SECOND AVENUE SUBWAY PHASE 2

NEPA RE-EVALUATION Proposed Design Modification: Ancillary A

March 2025

**Figure 1 - 2020 Approved Design:
Profile of Vertical Shaft at Ancillary A (View Westward)**

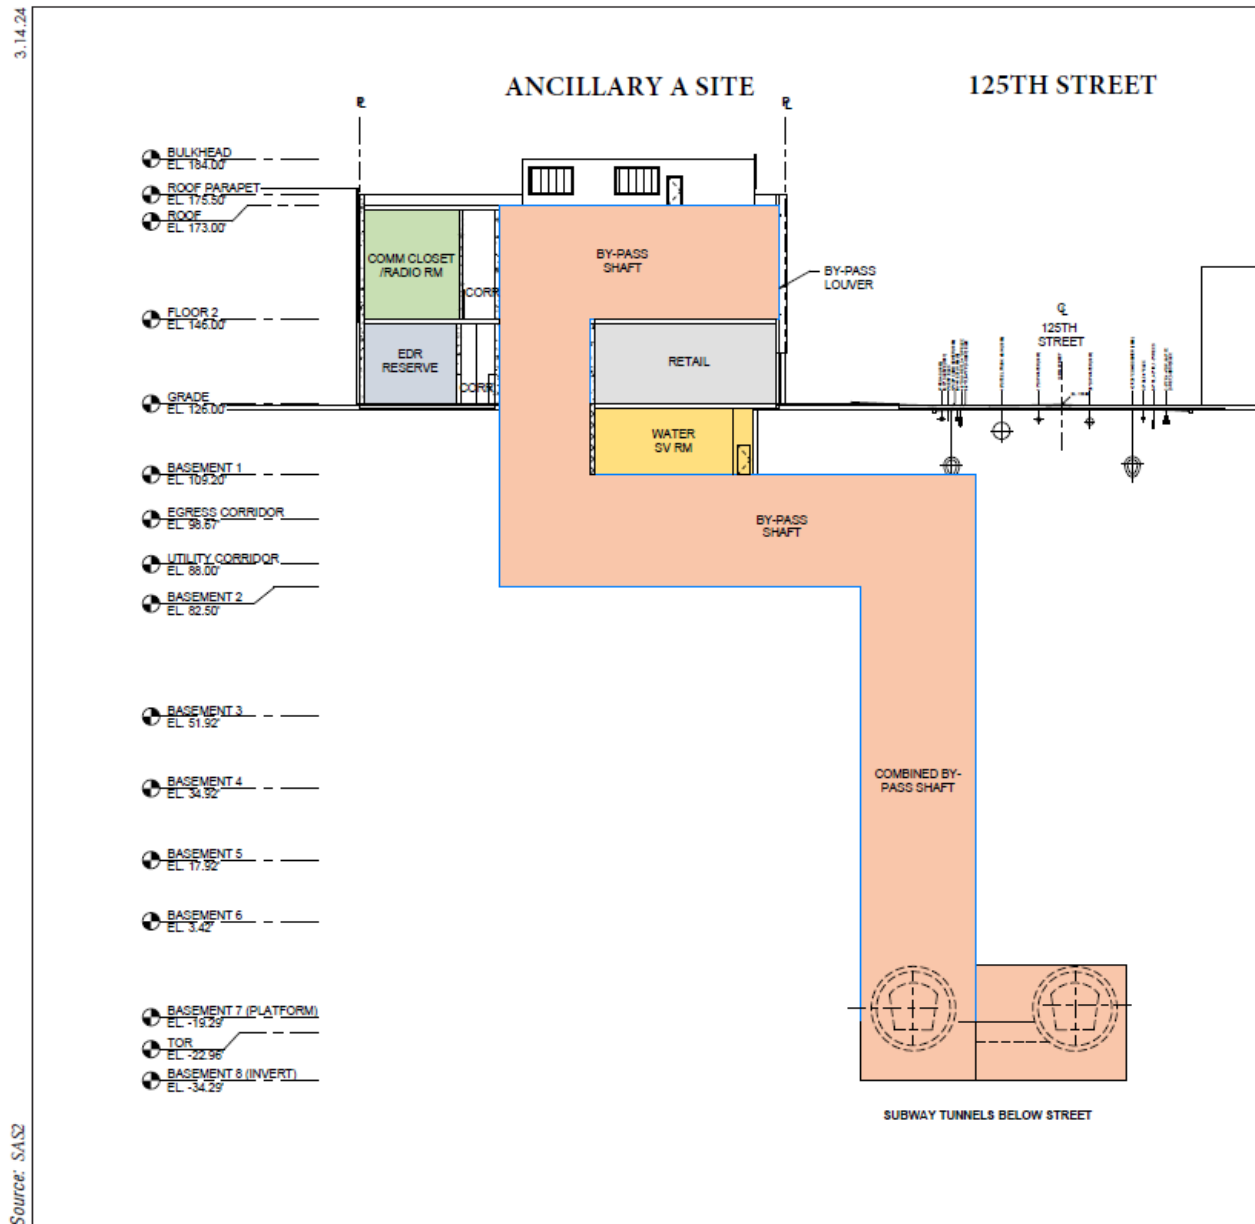
The 2020 design modification shifted Ancillary A from the site evaluated in the 2018 EA for the three-train option, at 118 West 125th Street (Lot 41 on Block 1909), to an adjacent, smaller property at 120 West 125th Street (Lot 44 on Block 1909). With the 2020 design, Ancillary A would be smaller (about 50 feet wide, 100 feet deep, and 40 feet tall) and would house less equipment. Most of the planned equipment would instead be located in a permanent vertical shaft beneath 125th Street that would connect the subway tunnels to the Ancillary A site. The vertical shaft would rise approximately 100 feet from the train tunnels beneath 125th Street and then connect to a horizontal shaft that would continue below ground to the lowest level of Ancillary A on the south side of 125th Street (see [Figure 1](#)). The shaft would house a tunnel ventilation duct, riser spaces for ducts and pipes, and an emergency stair.

Similar to the 2004 FEIS and 2018 Supplemental EA, the tunnels for the tail tracks beneath 125th Street would be constructed via mining with a TBM. The TBM would be removed from the end of the tunnels using the vertical shaft in 125th Street rather than using the Ancillary A site, which would not be large enough for TBM removal.

Figure 2 - Proposed Design Modification: Project Site

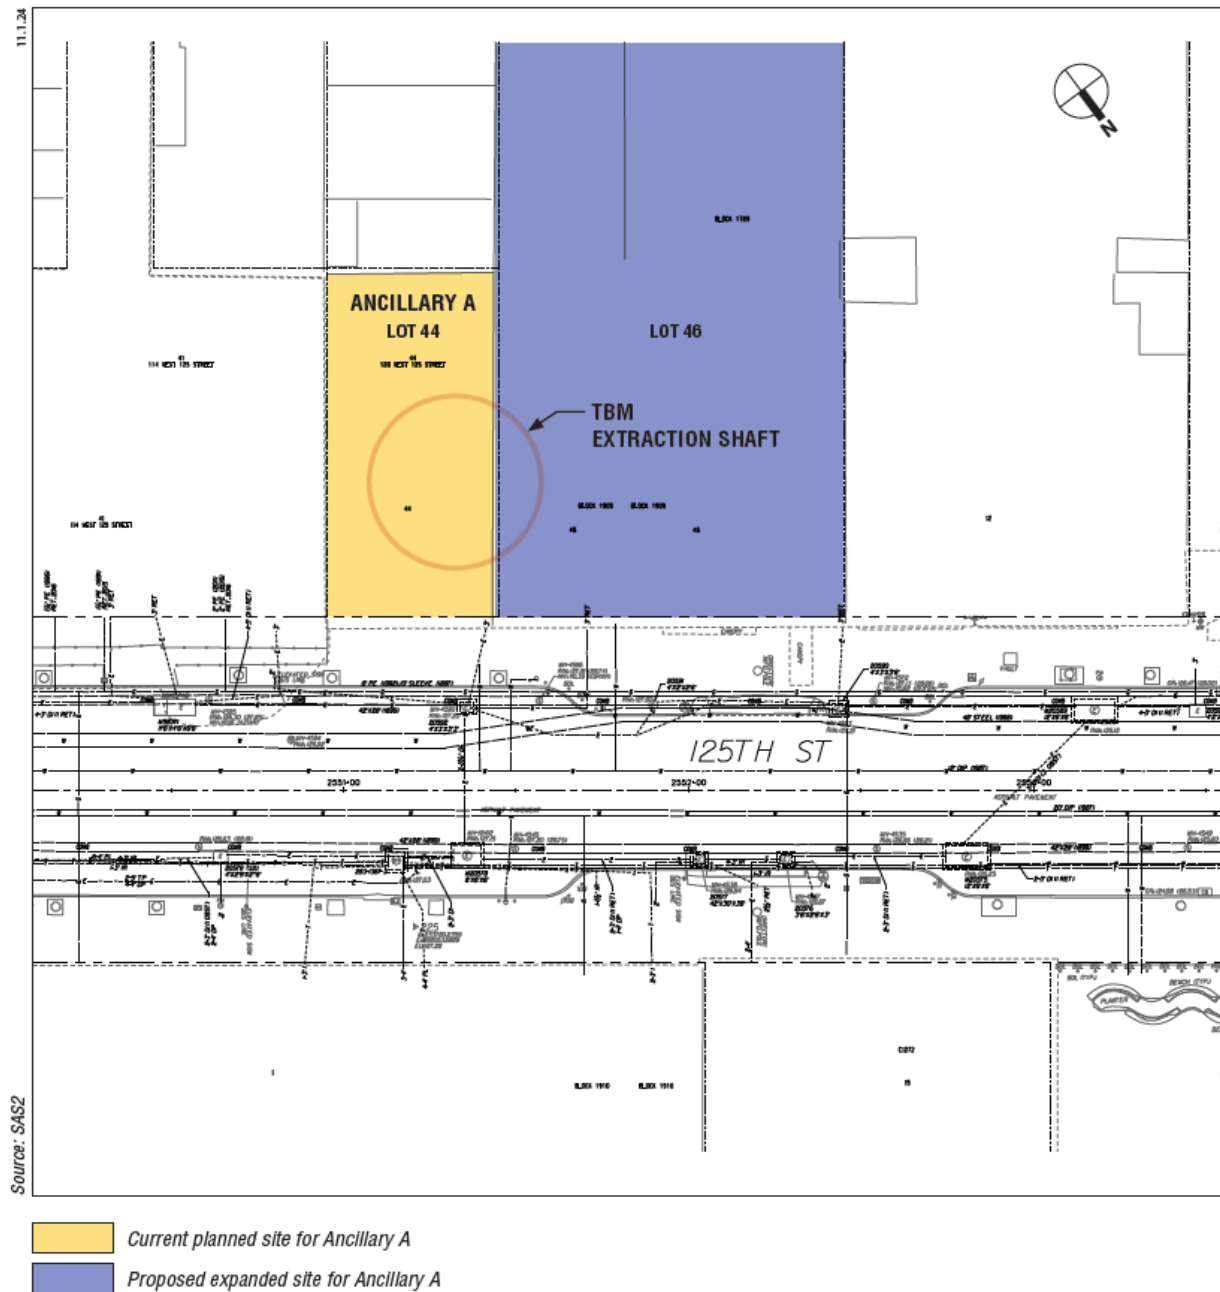
Therefore, MTA is now proposing to use Lot 44 and the adjacent property at Lot 46, at 124 West 125th Street (see [Figures 2 and 3](#)). Lot 46 is 100 feet wide on West 125th Street and extends through the block to West 124th Street, where it is also 100 feet wide. This would accommodate the 60-foot-diameter vertical shaft. With this design modification, the planned vertical shaft connecting to the train tunnels would be shifted from within 125th Street to an off-street site on Lots 44 and 46, similar to the design evaluated in the 2018 Supplemental EA (see [Figures 4 and 5](#)).

**Figure 6 – Comparison of 2020 Approved Design and Proposed Design Modification:
Profile of Vertical Shaft at Ancillary A (View Westward)**

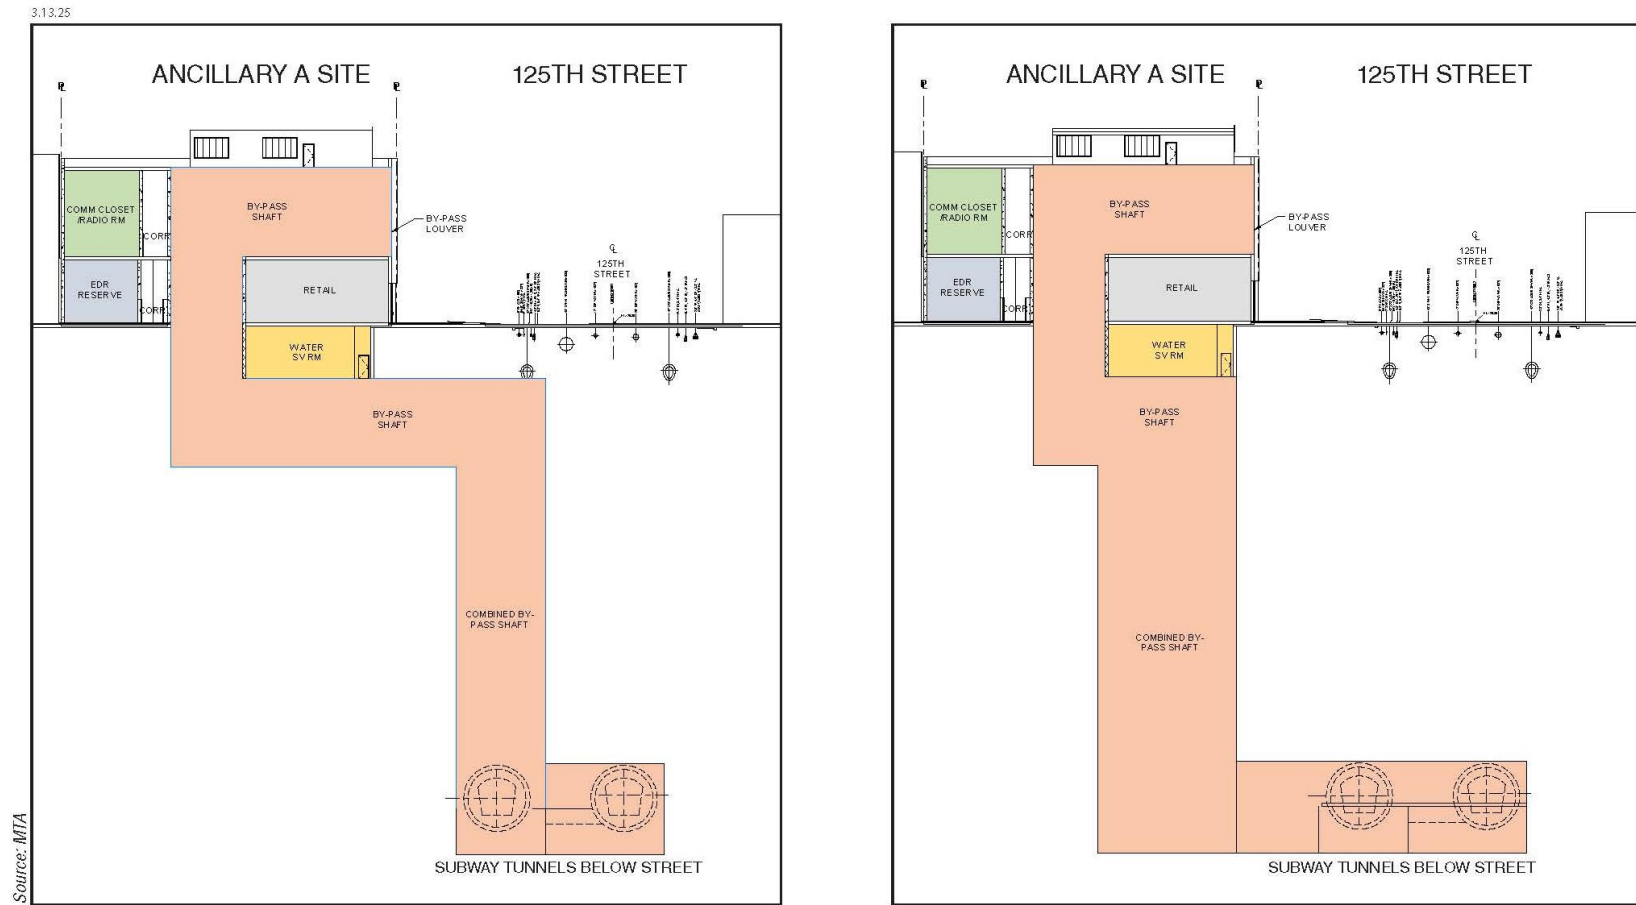
To avoid that disruption, MTA is now proposing to shift the permanent vertical shaft out of 125th Street to the Ancillary A site. That off-street location would also be used for removal of the TBM. However, the current site for Ancillary A on Lot 44 is too small to accommodate the vertical shaft and removal of the TBM; it also does not provide sufficient space for the construction contractor to stage TBM activities, such as spoils removal and processing and contractor access to the tunneling. Lot 44 is 50 feet wide (along West 125th Street) and 100 feet deep, but to accommodate removal of the TBM, the vertical shaft, including its support walls, must be approximately 60 feet wide.

With this design modification, Ancillary A would be approximately 80 feet wide, 100 feet deep, and 45 feet tall. As design proceeds, MTA may elect to reduce the building's height and instead increase its frontage along 125th Street. When the Project is complete, if excess property is available on the two lots, MTA may pursue a joint development opportunity (e.g., with a private developer) or dispose of the excess property. Those actions would be subject to further NEPA evaluation at that time.

Figure 7 – Comparison of Designs for Tail Tracks and Ancillary Facility:
2004 FEIS, 2018 Supplemental EA, 2020 Re-evaluation, and Proposed Design Modification

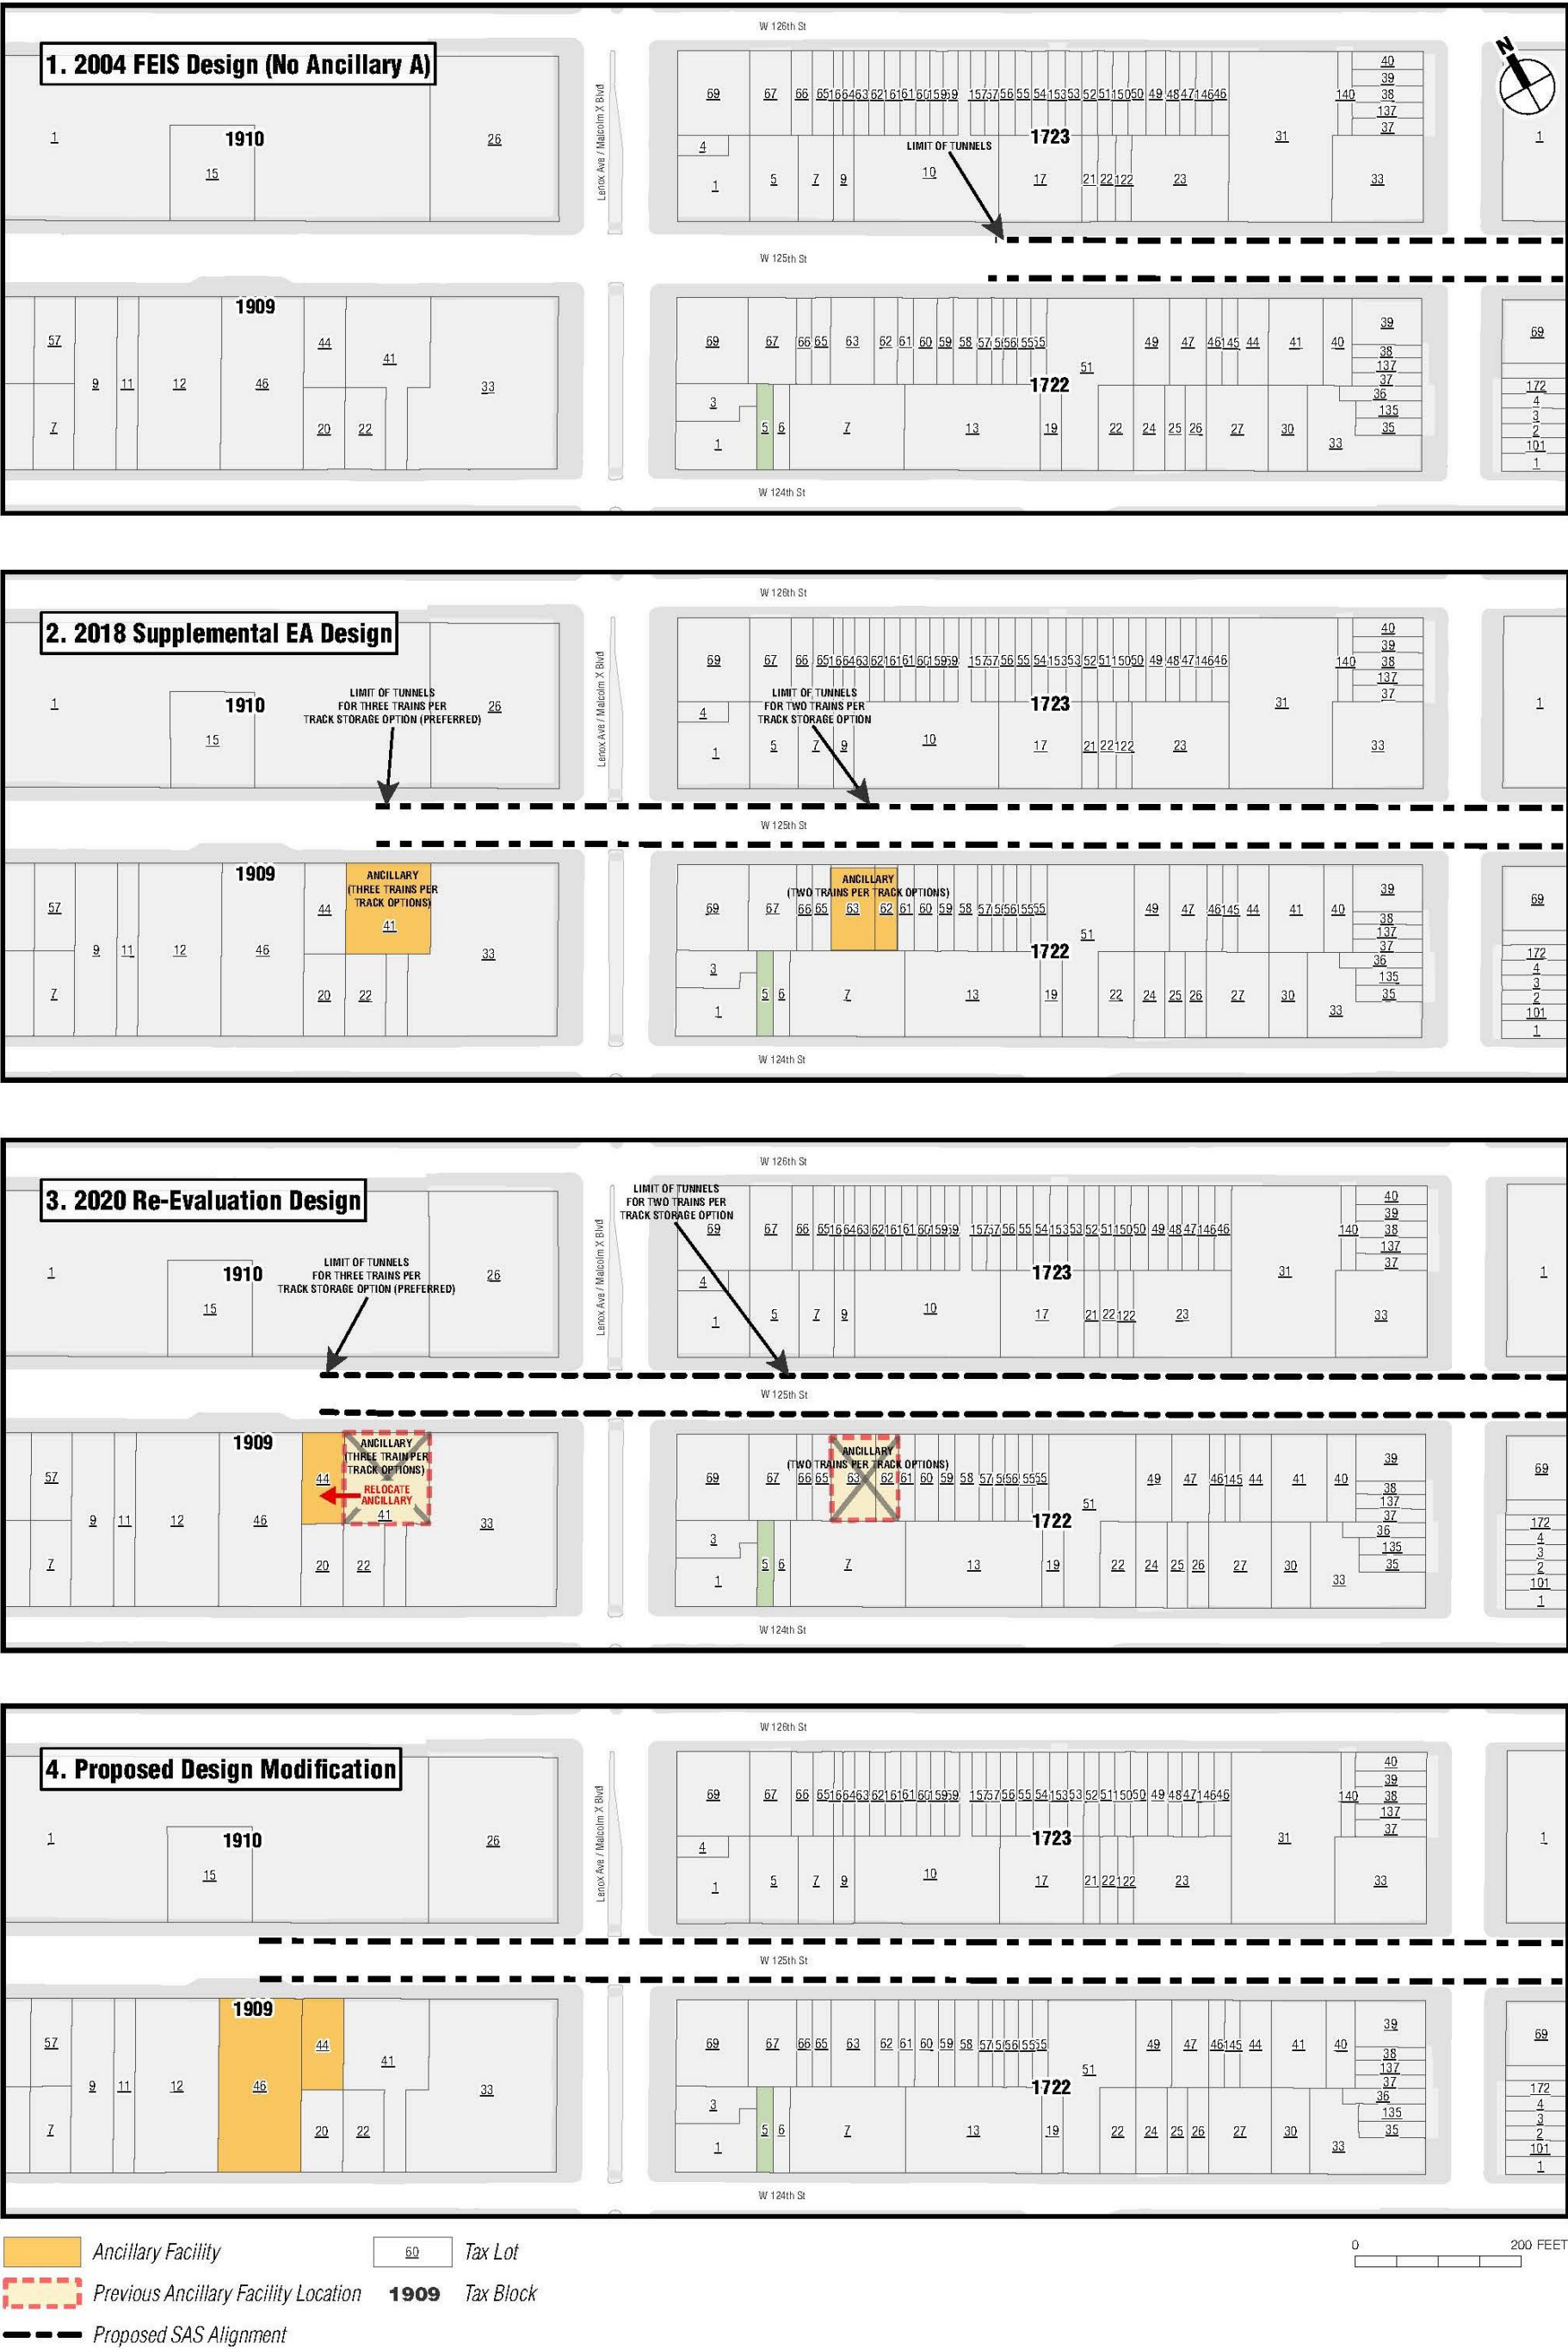
Table 1 below summarizes the design for Ancillary A in the 2004 FEIS, 2018 Supplemental EA, 2020 design modifications, and the currently proposed design modifications. [Figure 6](#) provides a side-by-side comparison of the ancillary facility in the approved (2020) design and the currently proposed design modifications and [Figure 7](#) illustrates the changes to the proposed site plan for Ancillary A between 2004, 2018, 2020, and the currently proposed design.
